Planning Board Staff Report

TO: Marco Island City Council

FROM: Daniel J. Smith, AICP, Director of Community Affairs

RE: Conditional Use Permit (CUP): 25-000097 – Sec. 30-264 - Conditional Use to allow for marina-based open rack boat storage facilities on navigable water frontage, pursuant to Sec. 30-266.

Proposed DEP Plan

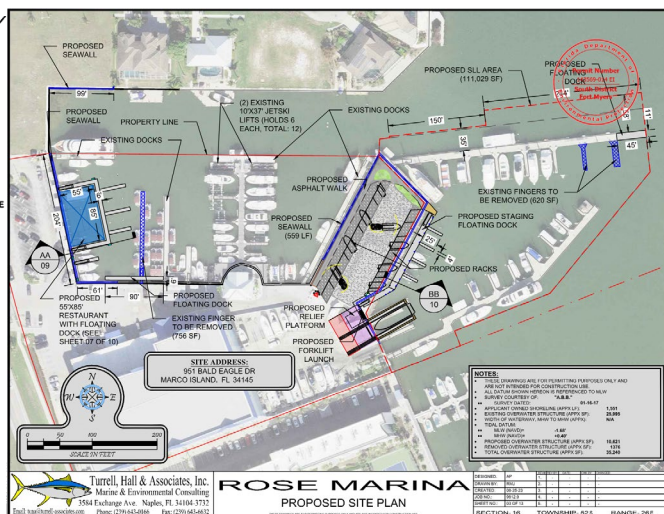
Staff have no issue with approving the twenty (20) outdoor boat racks. Staff believes the outdoor racks/slips are needed to service the boating community of Marco Island. However, the code does require this storage to be screened. As provided by the applicant, the storage of boats may reach a height of 16', while the fence is 4' in height. The City's Land Development Code does not allow any discretion regarding the screening requirements except when abutting developed C-5 property, for which written approval is required from the property owner.

The use, as proposed with the required screening, would be compatible with adjacent and nearby property. Right now, compatibility would be in question because the proposed screening is not high enough to fully screen the racks and the boats from view..

1. CUP-25-000097 is conditioned on the approval of SDP 24-000200. If the SDP is not approved, this application is null and void.
2. The Owner shall provide a 16' high screening fence or similar type screening for the outdoor storage proposed.
3. The number of outdoor open rack/slips shall not exceed twenty (20) in total.
